Access Compliance Report

Public Rights-of-Way

Intersection ID: 32311	Main Street: LAUREL_WALK_CT	Cross Street: NEW_PROVIDENCE_LN	Location: SE
ADA ID: B540CD732B60	Ramp Type: PerpDiag	Initial Pass/Fail: Fail	Overall Compliance: No
Severity Score: 22.5			
Codes/Mitigation Info/Possible Solution		Field Measurements/Component Compliance

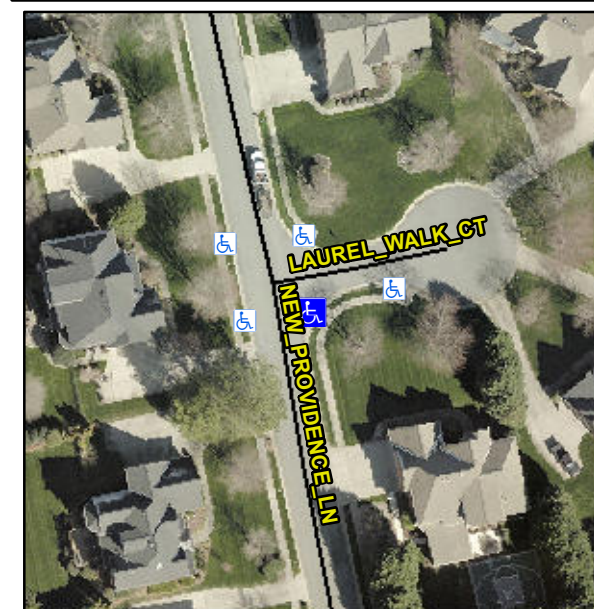
Not Found, R304.5.1, R304.2.2, R304.5.3

Compliance	Description	Data	Compliance	Description	Data
N/A	Ramp Length (in)	48.0	No	Ramp Slope (%)	9.0
No	Ramp Width (in)	43.0	No	Ramp XSlope (%)	2.7
N/A	Flare Type LT	N/A	N/A	Flare Type RT	N/A
N/A	Flare Slope LT (%)	N/A	N/A	Flare Slope RT (%)	N/A
N/A	Flare Traversable LT?	N/A	N/A	Flare Traversable RT?	N/A
N/A	Landing Length (in)	N/A	N/A	DWS Provided?	N/A
N/A	Landing Width (in)	N/A	N/A	DWS Contrast?	N/A
N/A	Landing Slope (%)	N/A	N/A	DWS Length (in)	N/A
N/A	Landing X Slope (%)	N/A	N/A	DWS Full Width?	N/A
N/A	Landing Curb? (Y/N)	N/A	N/A	DWS Offset (in)	N/A
N/A	Shared Landing?	N/A			
N/A	Gutter Ponding?	N/A	N/A	Gutter Slope (%)	N/A
N/A	Gutter Lip Ht (in)	0.5	N/A	Gutter X Slope (%)	N/A
N/A	Painted X Walk1?	No	N/A	Painted X Walk2?	No
	X Walk 1 Direction	To N		X Walk 2 Direction	To W
N/A	X Walk 1 Width (in)	N/A	N/A	X Walk 2 Width (in)	N/A
	X Walk 1 Slope (%)	1.5		X Walk 2 Slope (%)	2.3
	X Walk 1 X Slope (%)	0.9		X Walk 2 X Slope (%)	2.3

Remove & Replace Curb Ramp With Two New Directional Ramps or Equivalent.
